AGENDA

NEC Code-Making Panel 15 (NEC P15) NFPA 70 Second Draft Meeting (Annual 2025)

October 24 - 26, 2024
8:00 a.m. – 5:00 p.m. (PT)

Figure 1

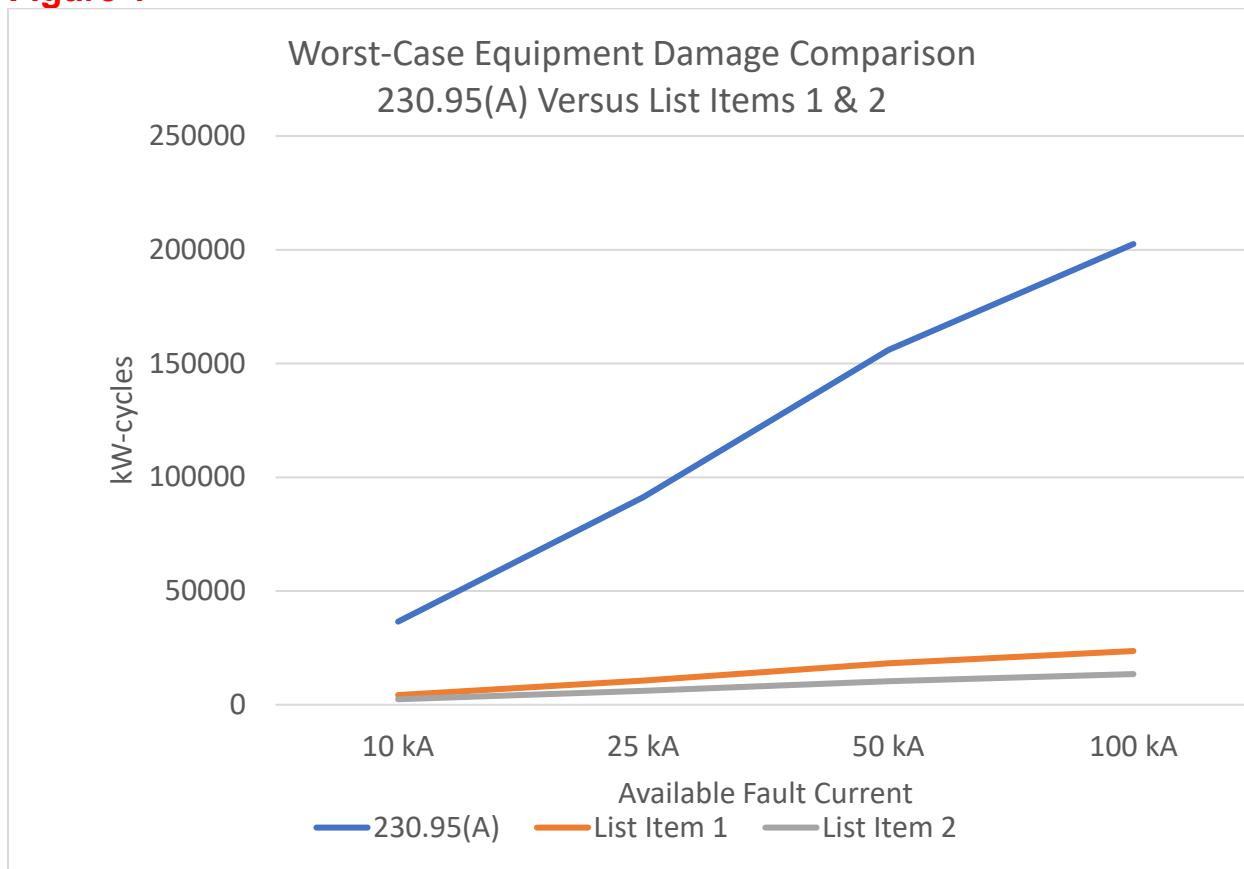
The IEEE 1584-2018 minimum arcing current is 6.09kA. Using the maximum 230.95(A) opening time of 60 cycles, the equipment damage is (6.09 kA X 60 cycles X 100 arcing volts) = 36,540 kW-cycles. See Figure 1.

The IEEE 1584-2018 minimum arcing current is 6.09kA. Assuming an opening time of 4 cycles for 240.87(B)(1), (B)(2), or (B)(4), the equipment damage is (6.09 kA X 4.0 cycles X 100 arcing volts) = 2,436 kW-cycles. Assuming an opening time of 3 cycles for 240.87(B)(5) or (B)(6), the equipment damage is (6.09 kA X 3 cycles X 100 arcing volts) = 1,827 kW-cycles. Worst-case damage for the minimum arcing current with this exception for circuit breakers (2,426 KW-Cycles) is less than 7% of the worst-case damage allowed by 230.95(A) (36,540 kW-cycles). See Figure 1.

Figure 1 shows that equipment damage allowed by this Public Comment is always, from 10,000 amperes available through 100,000 amperes available, just a small fraction of the equipment damage allowed by 230.95(A).

Figure Informational Note 517.31(B)(1) Type 1 EES — Minimum Requirement (Greater Than 150 kVA) for Transfer Switch Arrangement.

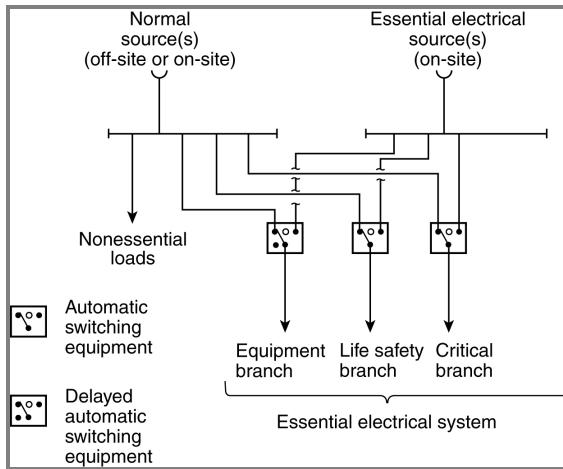
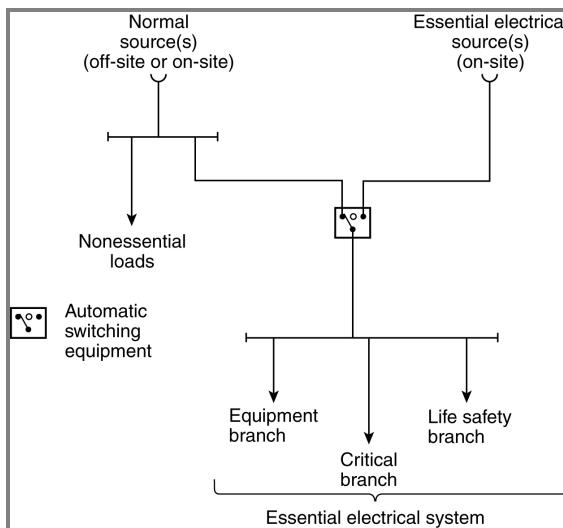
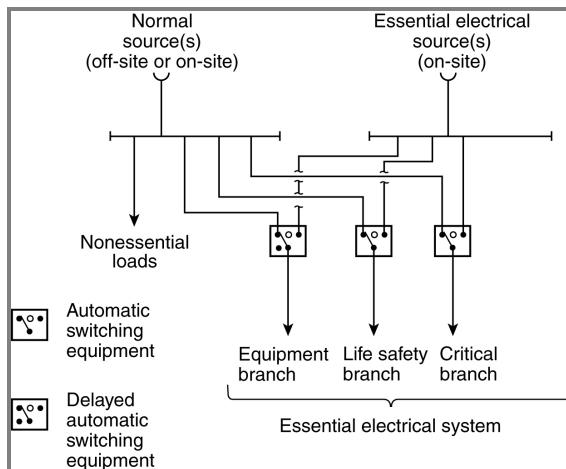
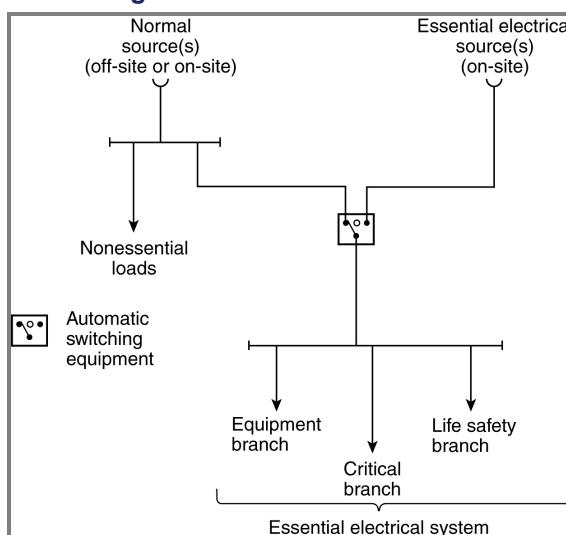
The original PI attempts to correct some language that could be misinterpreted to mean it is permissible to use multiple transfer switches that mix the branches as long as the load in each transfer switch is kept below 150kVA. The intent is to allow smaller facilities with small essential electrical systems to not have to divide the EES into separate branches. However, since the requirement is written based on the load on the transfer switch and not the total EES load, it could be allowable to mix the branches on a very large EES as long as the load on each individual transfer switch was kept below 150kVA. This could compromise the safety and reliability of key systems directly related to life safety and patient care.

Figure Informational Note 517.42(B)(1) Type 2 EESs (Nursing Home and Limited Health Care Facilities) — Minimum Requirement (Greater Than 150 kVA) for Transfer Switch Arrangement.

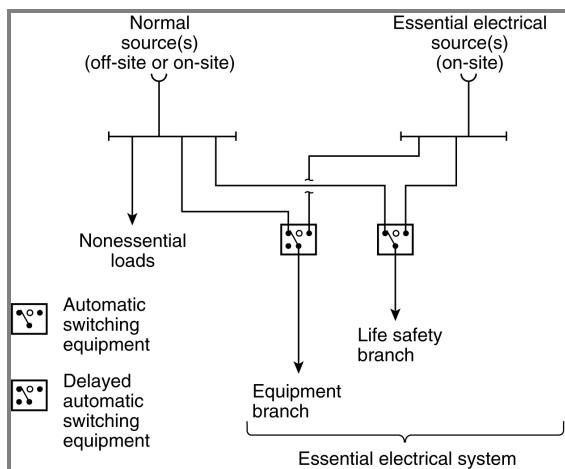
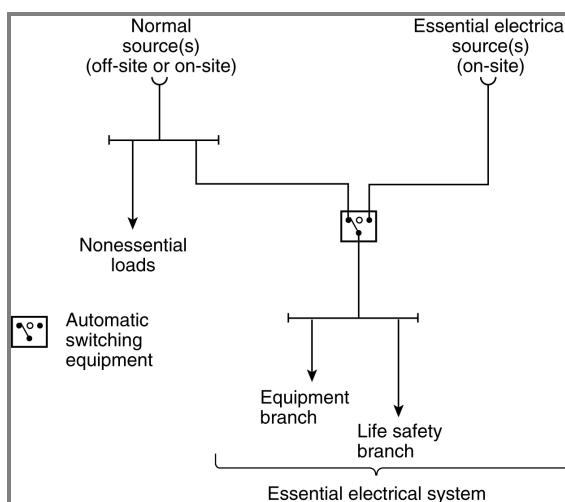
The original PI attempts to correct some language that could be misinterpreted to mean it is permissible to use multiple transfer switches that mix the branches as long as the load in each transfer switch is kept below 150kVA. The intent is to allow smaller facilities with small essential electrical systems to not have to divide the EES into separate branches. However, since the requirement is written based on the load on the transfer switch and not the total EES load, it could be allowable to mix the branches on a very large EES as long as the load on each individual transfer switch was kept below 150kVA. This could compromise the safety and reliability of key systems directly related to life safety and patient care.
